## **Milwaukee County Parks CMP Amendment Application**

# HUNGER TASK FORCE GRANARY ALTERATION & ADDITION

JUNE 17, 2015  
**95% REVIEW DOCUMENTS**

**A100**

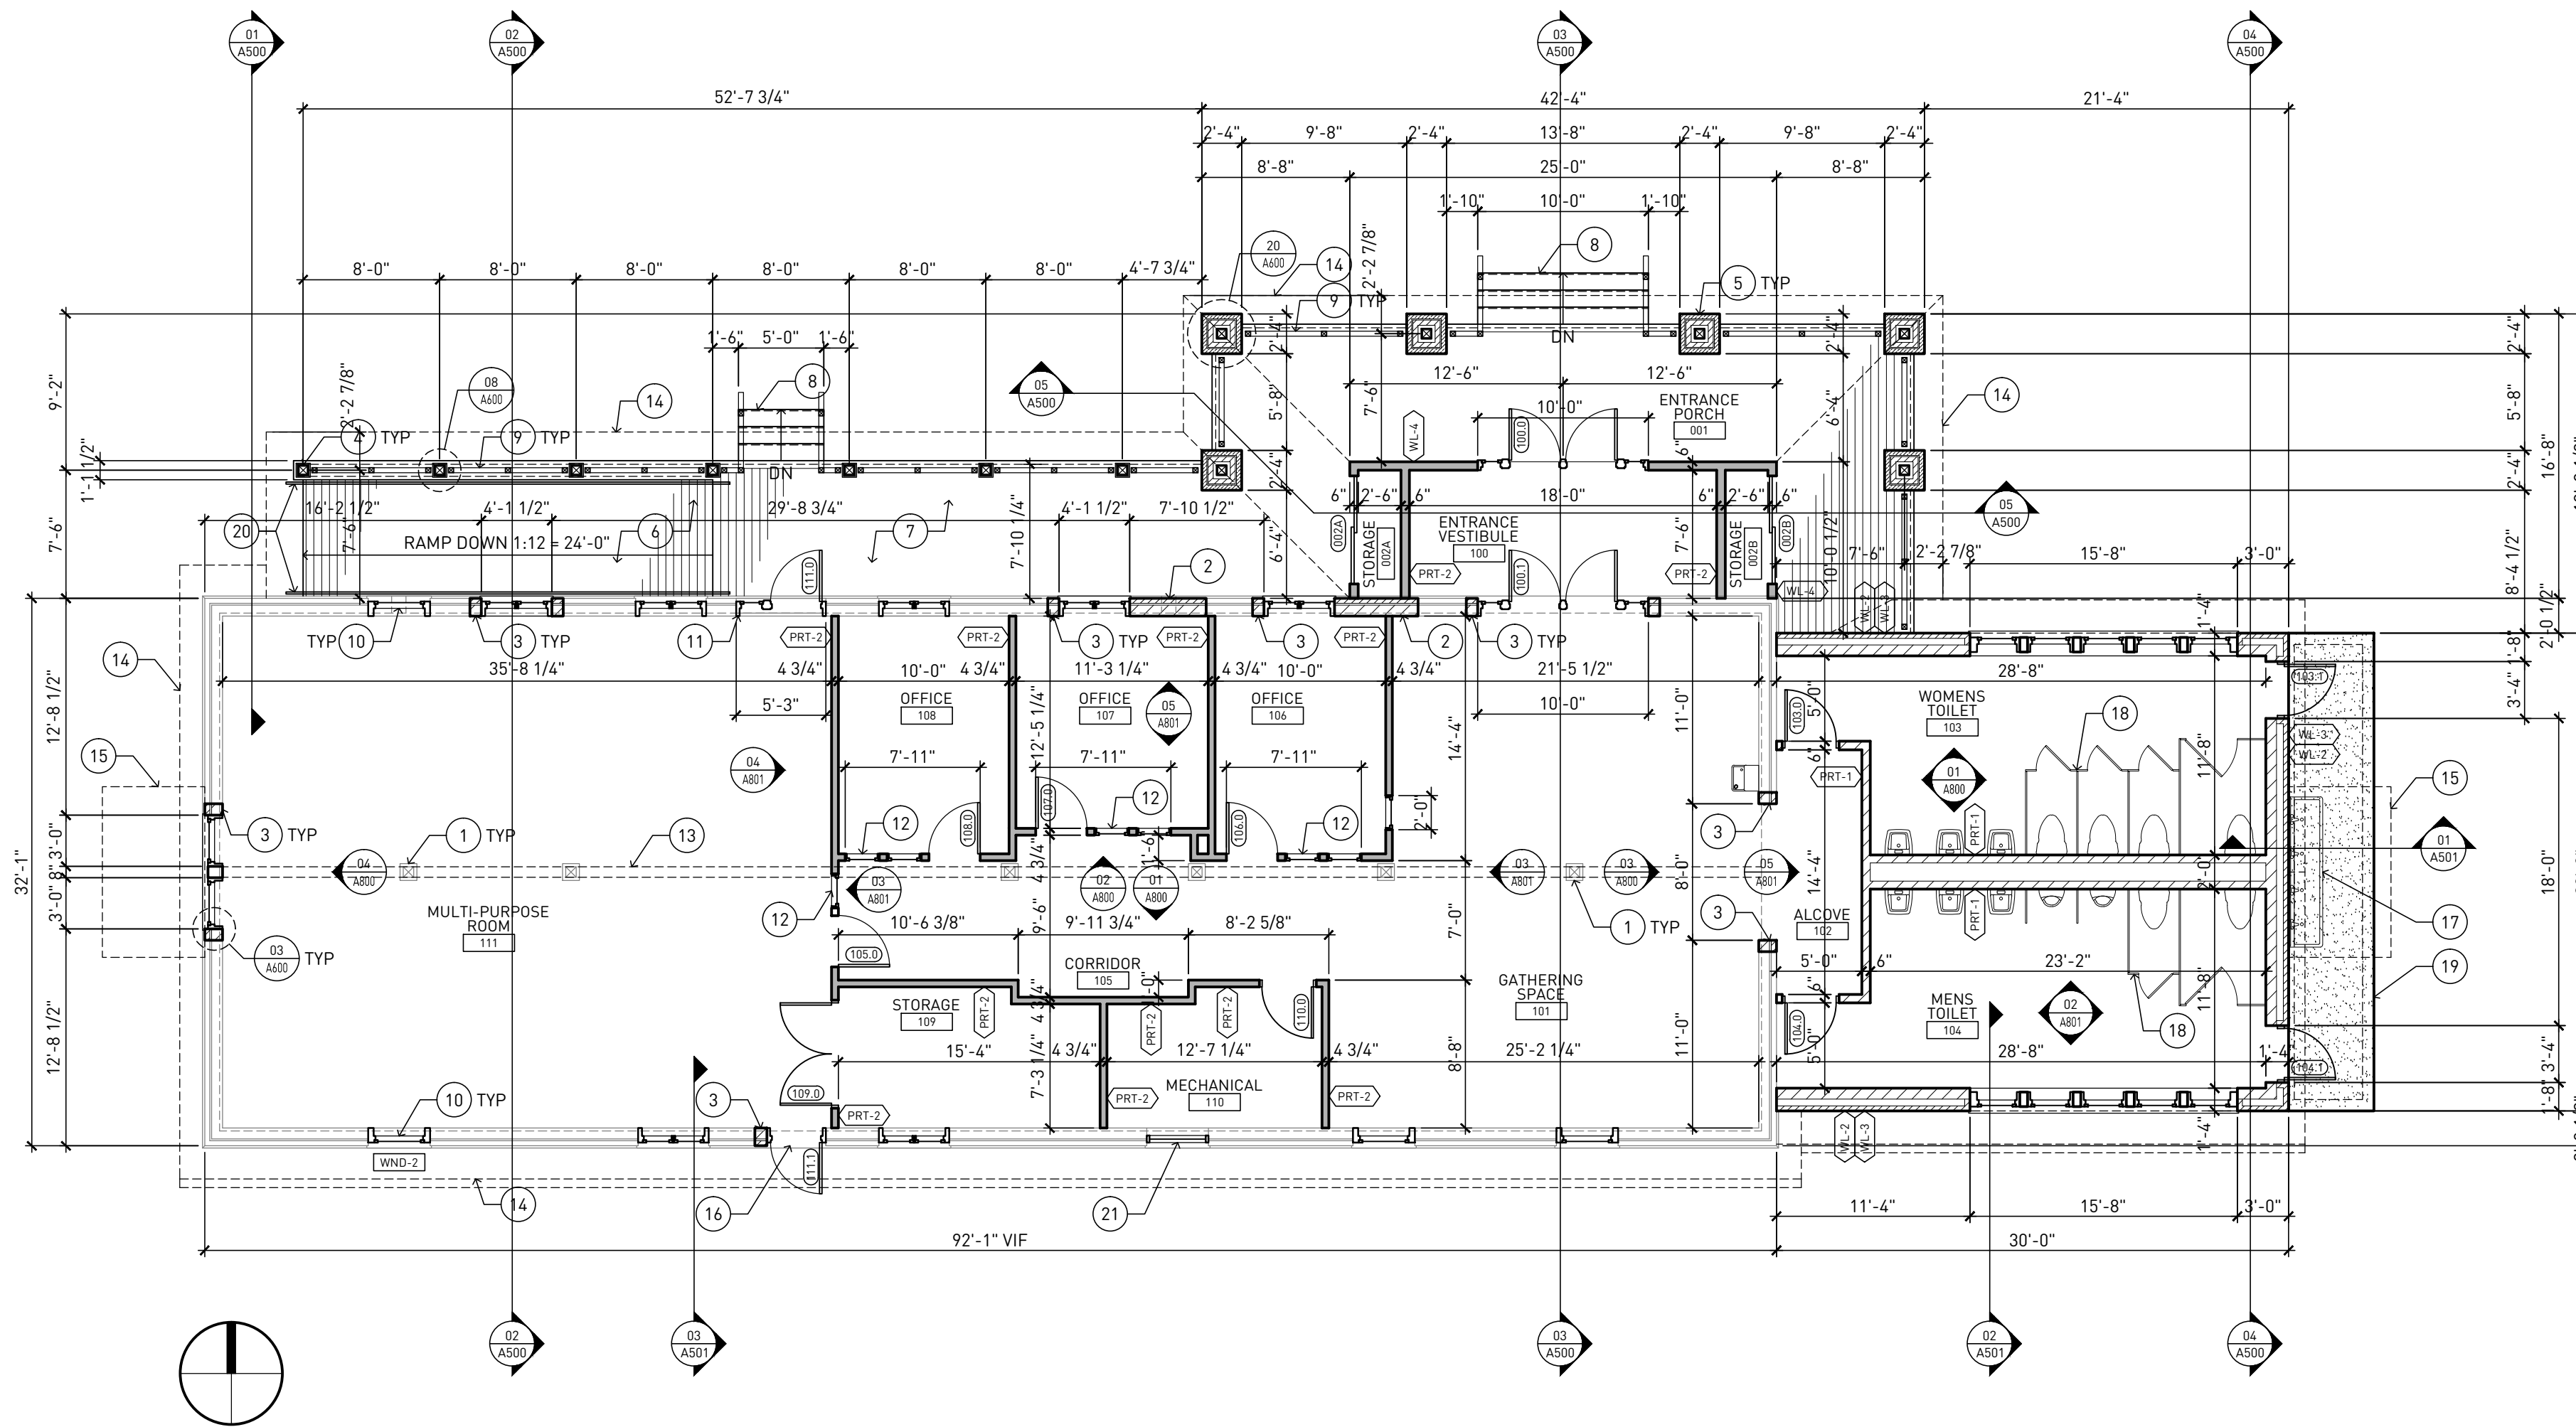
1. Please illustrate on the site plan and provide details for storage of trash dumpsters and garbage receptacles. Trash facilities must provide sight-proof fencing (wood or masonry) and landscaping to totally obstruct vision into the garbage storage area. Section 15-3.0803(I) of the UDO defines the detailed standards for trash dumpsters and garbage receptacles. If no dumpsters are required, please indicate and explain in a revised letter of intent or supplemental letter how garbage will be taken care of on your site.

**RESPONSE: Details for dumpster storage has been added to the site plan.**
